PLANNING AND ZONING CASE CHECKLIST

PLANNING AND ZONING DEPARTMENT 385 S. GOLIAD STREET ROCKWALL, TX 75087

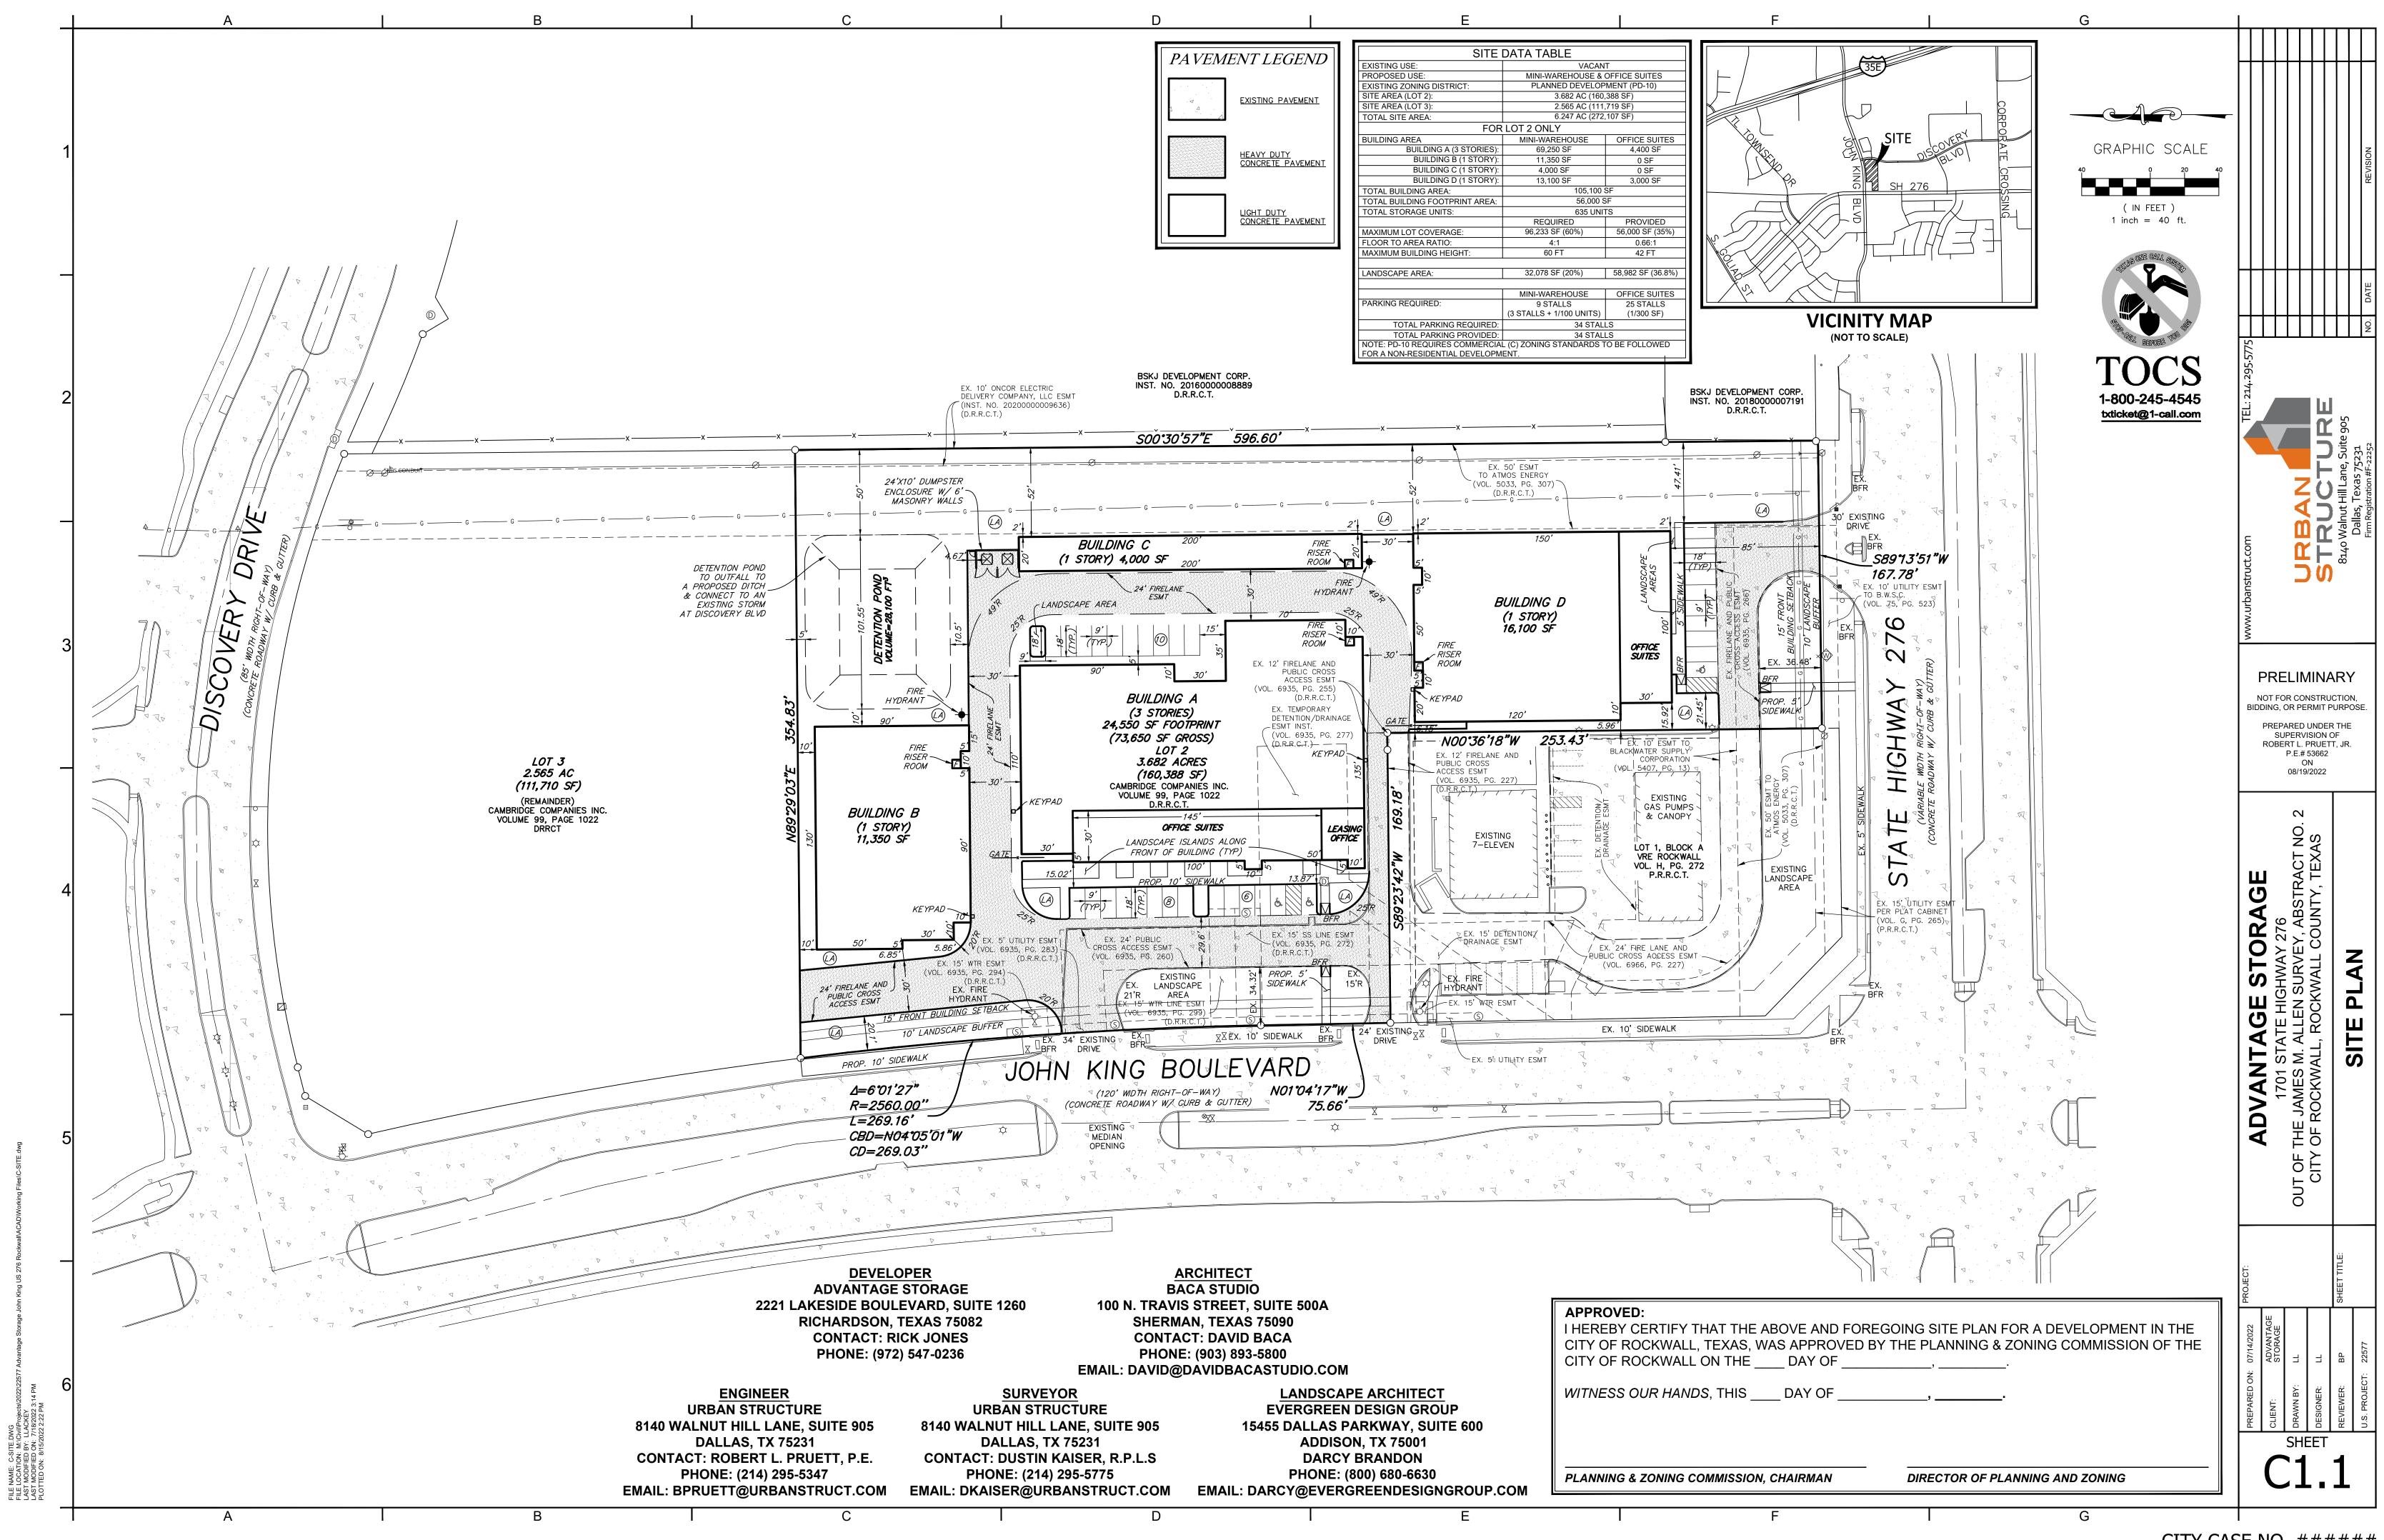
P&Z CASE # P&Z DATE_09/13/2022	CC DA	ATE Approved/Denied
ARCHITECTURAL REVIEW BOARD DATE 09/13/2022	HPAB DATE_	PARK BOARD DATE
Zaning Application		
Zoning Application		Copy of Ordinance (ORD#)
 Specific Ose Permit Zoning Change 		Applications
 D Concept Plan 		Receipt Location Map
 PD Development Plan 		HOA Map
		PON Map
Site Plan Application		FLU Map
X Site Plan		Newspaper Public Notice
🗙 Landscape Plan		500-foot Buffer Public Notice
🗙 Treescape Plan		Project Review
Photometric Plan		Staff Report
Building Elevations		Correspondence
X Material Samples		Copy-all Plans Required
Color Rendering		Copy-Mark-Ups
District a Annullis attent		City Council Minutes – Laserfiche
Platting Application		Minutes-Laserfiche
 Master Plat Preliminary Plat 		Plat Filled Date
□ Final Plat		□ Cabinet #
\square Replat		□ Slide #
 Administrative/Minor Plat 	Notes:	
 Vacation Plat 		
□ Landscape Plan		
Treescape Plan		
HPAB Application
